# RELOCATED NEW BUILD

**Re: 594 Koutu Loop Road, Koutu Point  
Geotechnical Drawing Review**

**Table 1 – Drawing Review.**

## Subfloor Details .1

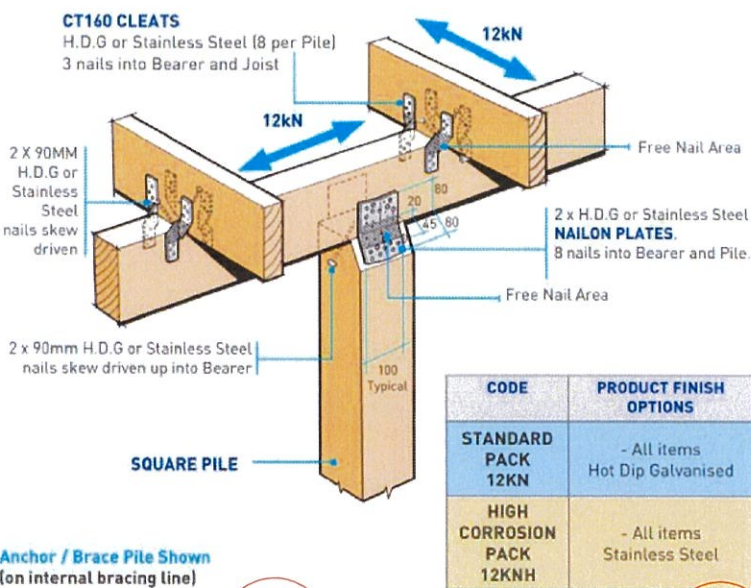
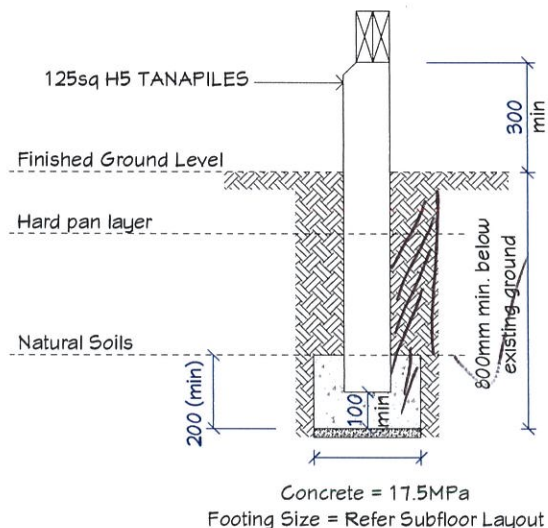
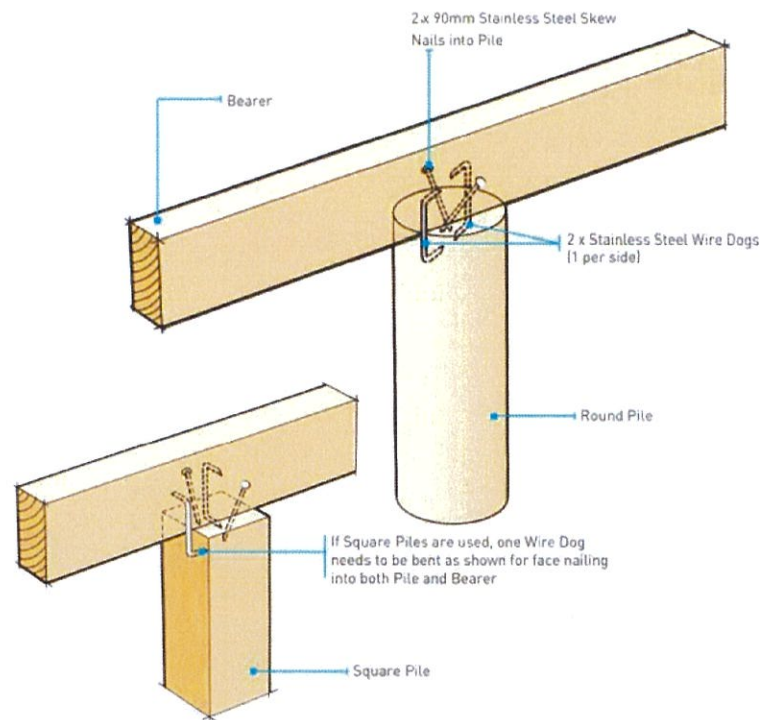
Sheet No	Date	Comments 29/08/2022
11 of 12 – Subfloor Details	26/08/2022	Correct embedment depth shown. We suggest filling all holes with concrete rather than just the bottom 200 mm. Minor amendments to anchor pile to make it clearer.
